## **AMENDED DA2021/2622**

### **ADDRESS – 65 HILLSIDE ROAD NEWPORT**

**AMENDED ELEVATION VIEWED FROM 67 HILLSIDE ROAD**

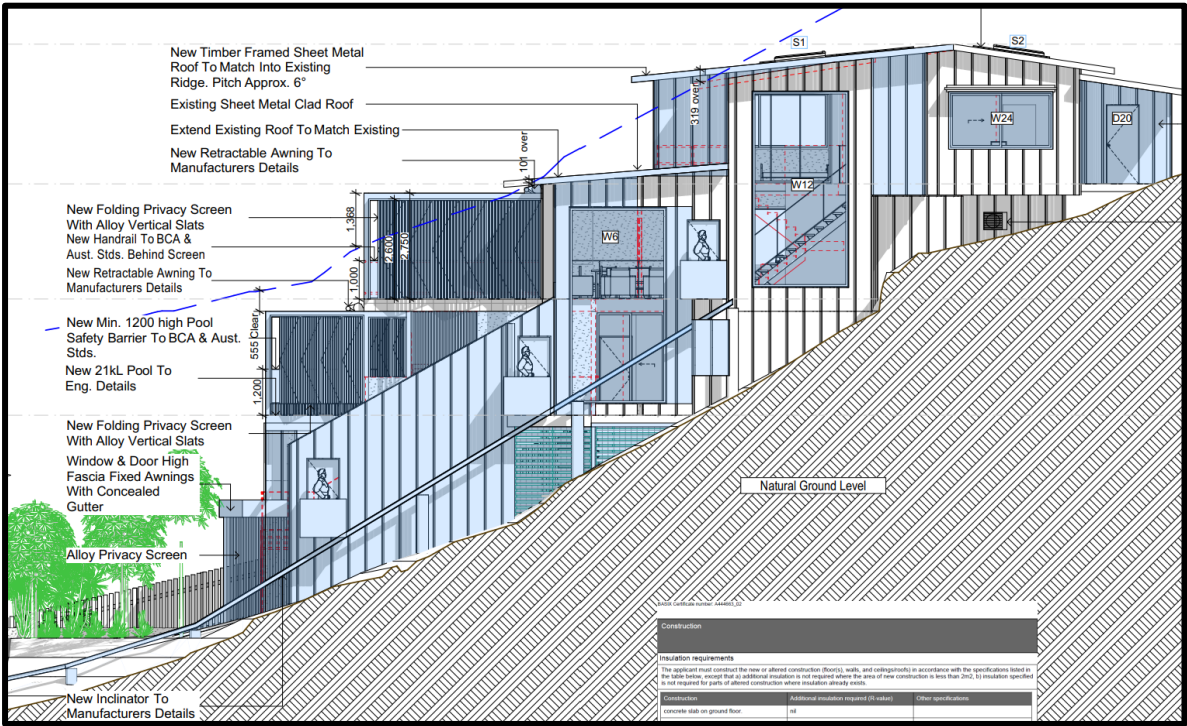
Secondly, and more importantly, the proposed inclinator, despite the minor amendments, will remain an offensive element due to its setbacks (non-compliant) and its proposed height with associated significant privacy impacts.

The following extract from the amended DA plans is testament to the offensive nature of the proposal and its entire disregard for the preservation of privacy of adjacent areas of visual sensitivity and the rejection of the controls within P21DCP, specifically with regard to setbacks and sensitive design solutions to preserve neighbours amenity.

This issue is unresolvable with the inclinator in the proposed location due to its proximity to the northern boundary and the excessive height above finished ground level.

Resolution could be achieved by either removing the inclinator entirely or relocating the proposed inclinator further (at least 2.5 metres to the carriage outer edge) as the extent of demolition will allow this resolution.
